ADDENDUM No. 4

Project: 2018 Athletic Improvement Project
Brownstown Central High School

Proj. No: 1741.01

Date: February 28, 2018

Drawing Original Survey

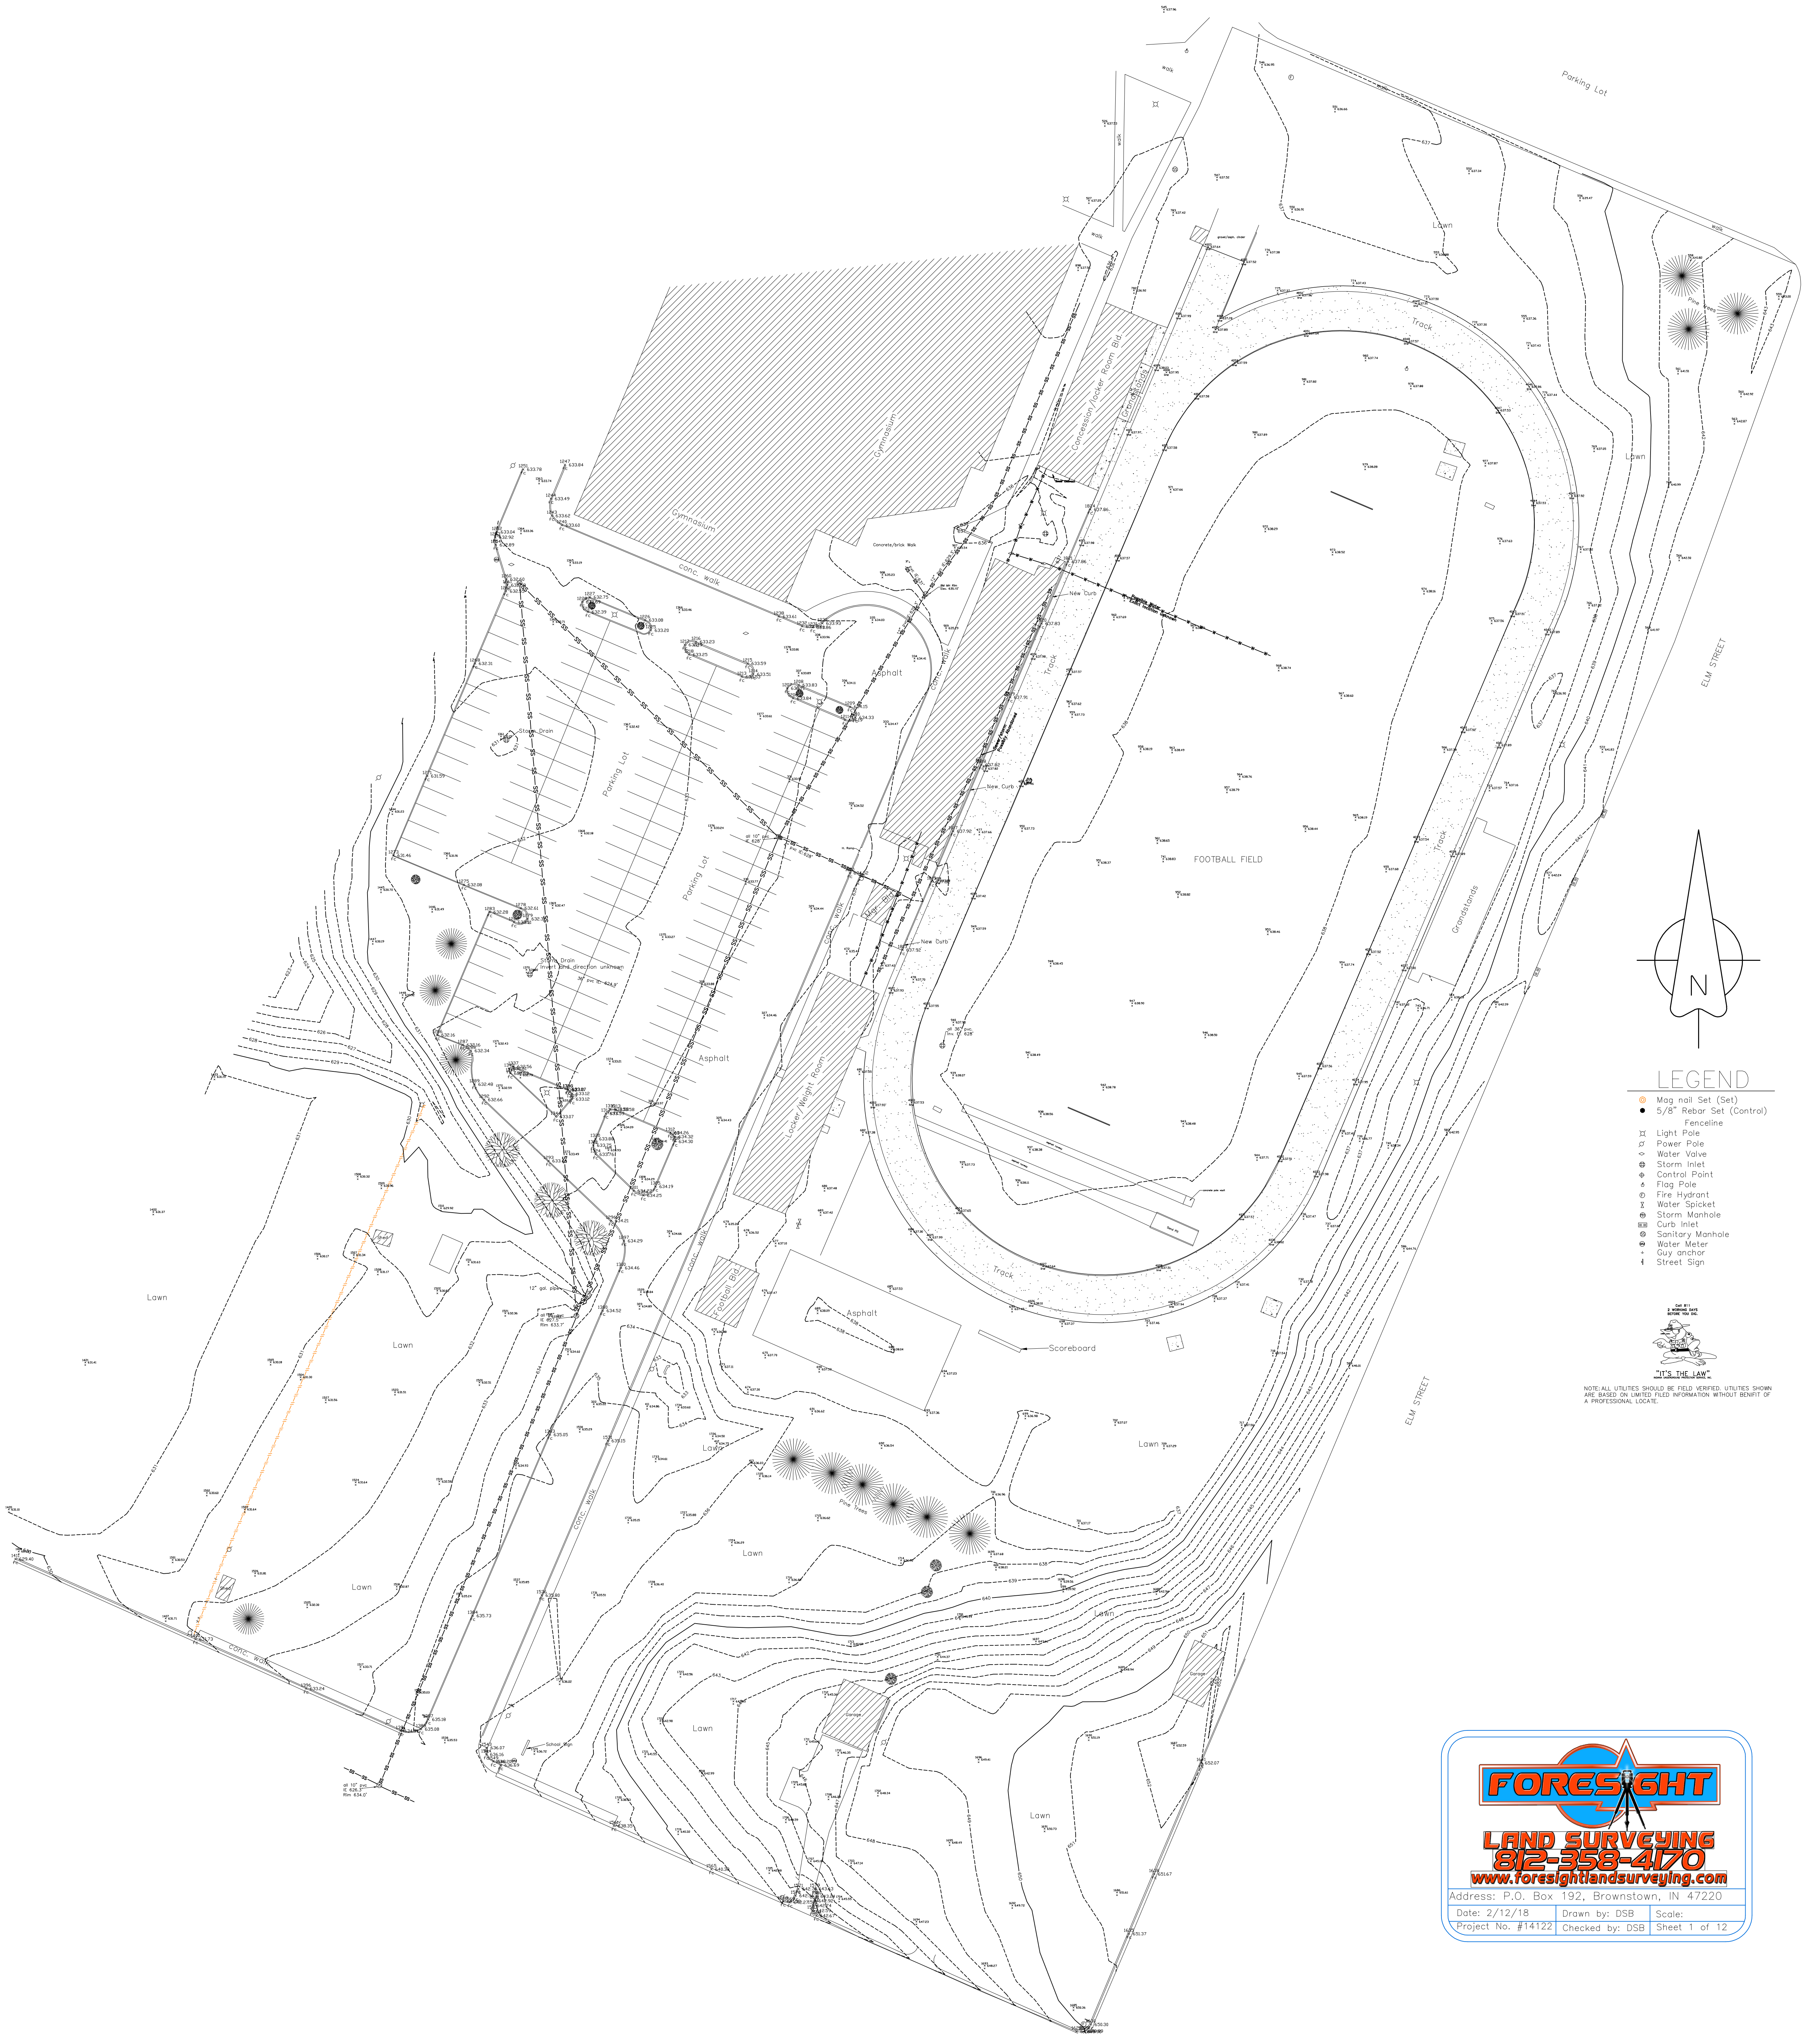
- For reference of all existing elevations, the original survey has been included to assist in grading cut/fill take-offs. See attached survey.
